November 29, 2024

**Re: Response to Technical Comments – SPC Application D07-12-24-0087; 2900 Brian Coburn Blvd./119 Ryan Reynolds Way**

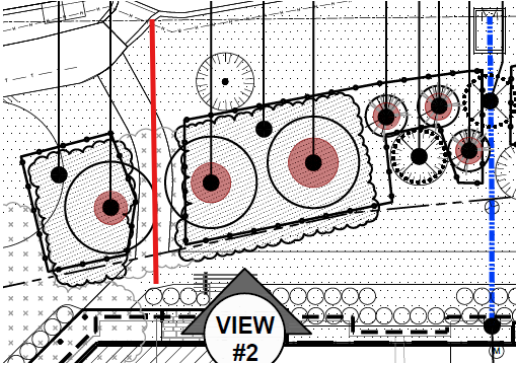
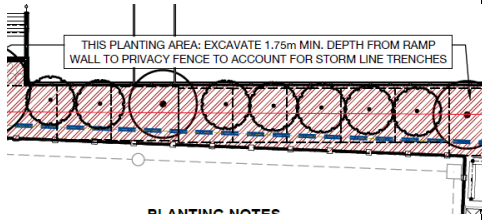
6. Tree # 10 is City owned. Removal would require justification. If justified, a permit and replacement planting is required. A white spruce would need to be planted as compensation. Please explain why the location of the watermain can not be moved? For	Please see revised Civil drawings and updated landscaping plan for the relocated watermain lines.

<p>example, placed under the walkway that connects pedestrians from Brian Coburn to the north west end of the building. Photo included for reference:</p> 	
<p>7. Tree 9 is also in close proximity to the watermain. Show the extent of excavation needed to install the watermain to confirm it does not conflict with the CRZ of this tree. Label the excavation distance from the watermain to the furthest extent of excavation.</p>	<p>Please see revised Landscaping plan. No ROW trees will be removed.</p>
<p>8. Please use an air spade instead of a hydrovac to excavate around retained City trees.</p>	<p>The plans have been revised. No excavation will be required.</p>
<p>9. There is a note on the Soil Volume Plan saying excavate 1.75m min. Depth from ramp wall to privacy fence to account for storm line trenches. At what depth are the storm line trenches? Has the engineering consultant confirmed there is no conflict with the proximity of these trees to the proposed storm pipe? Photo included for reference:</p> 	<p>There is no longer conflict with storm and trees as trees have been removed and replaced with native shrubs.</p>
